Service Letter #: SL15 66-12200

Part/Assembly #: Water rudder retract pulley, 66-15201 LSP Insulator, 66-12220-7.5 retract cable

Float Model Affected: Model 6650 Float Serial Numbers 142-143 and previous.

Symptom: Corrosion experienced by customers in marine environments.

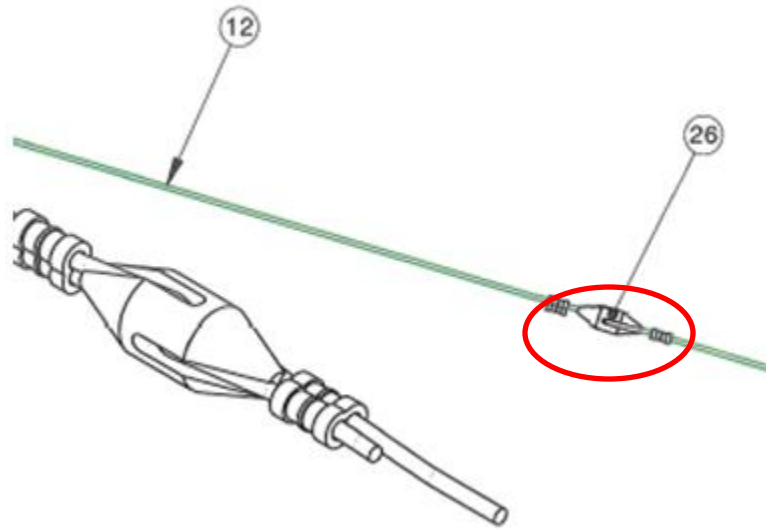
- (d) Discard the cable pieces. These will not be reused.
2. At the wye, below the aircraft, re-assemble the cables using the new assembly in place of the old. (The new assembly has no insulator in line. This will establish an electrical connection to the water rudder.) Apply anti-seize during bolt assembly at the wye, and also apply EZ-turn to it when completed.

3. Feed the loose end of the cable through the pulleys, then to the water rudder retract handle.

Old installation showing the 66-15201 insulator, which is to be removed and the entire cable replaced:

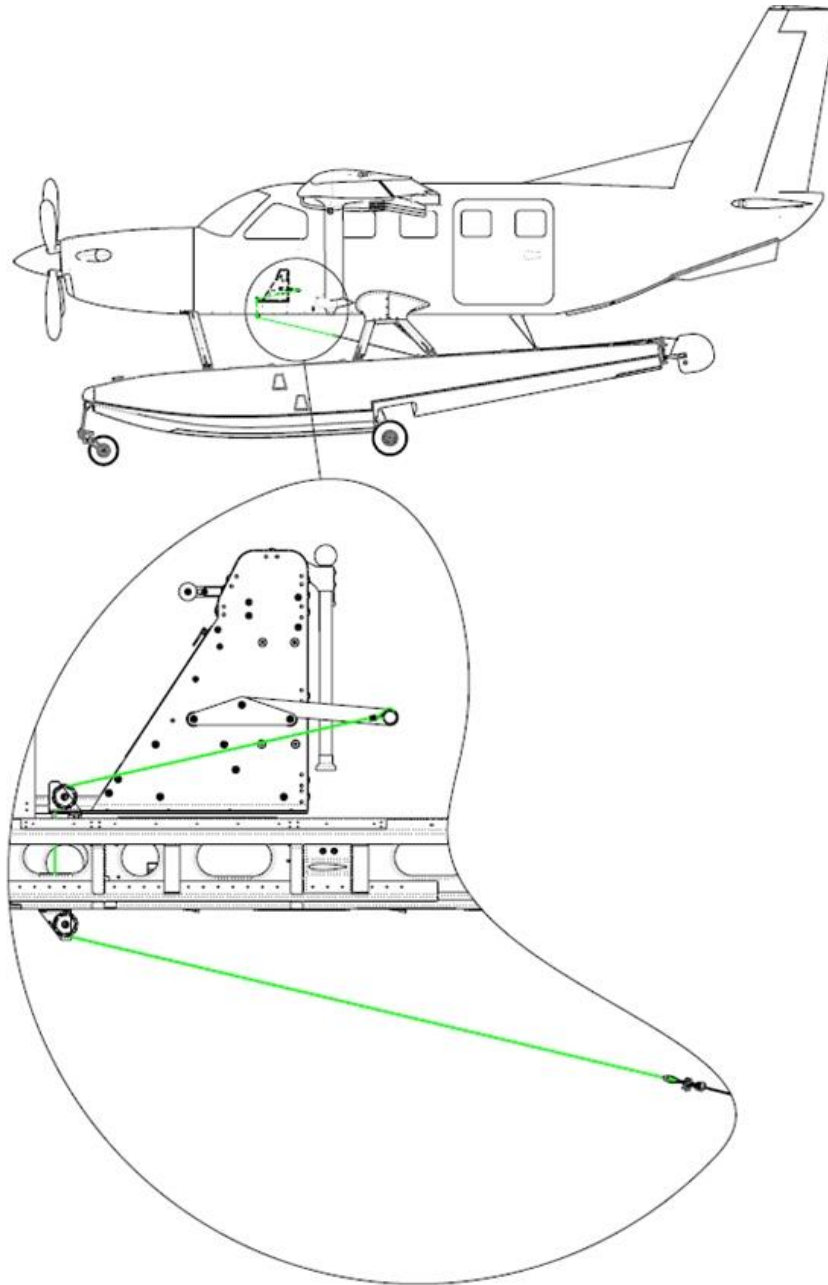
4. Slide on the shrink tubing (insulation sleeve) **M23053/5-106** prior to looping the cable around the cable eye and out of the way temporarily. (Will finish installing this in step 12.)
5. Install the cable eye (or thimble) **Part No. AN100C4** to the retract arm. (It will hang loosely around the bolt and bushing.)
6. Install the nicopress bushing loosely on the cable.
7. With the water rudder retract arm in the “down” position (fwd), loop the cable around the retract cable eye, assuring that the nicopress **Part No. MS51844-23** fitting is behind the eye. Feed the cable back through the nicopress fitting and push it snugly against the eye.
8. Temporarily secure the cable position using a u-bolt style clamp (provided). (DO NOT crimp the nicopress until the rudder position adjustment is verified.)
 - (a) Verify the water rudder position

- (b) Water rudder retract cable must be adjusted in such a manner that the rudder reaches the fully deployed position, against the stops.
 - (c) Additionally, there should be very little, if any slack in the cable when in the deployed position.
 - (d) Water rudder retract cable must be taught enough to pull the rudder highly enough behind the float as possible.
9. Once the position is verified, then crimp the nicopress fitting, assuring that it is firmly located against the cable eye.
10. Remove the u-bolt style clamp and trim the loose end of the cable closely to the nicopress fitting.
11. Slide the insulation sleeve over the nicopress, particularly over the trimmed cable.
12. Carefully apply heat until it is fully compresses on the cable. (Intent is to prevent injury from frayed cable ends.)
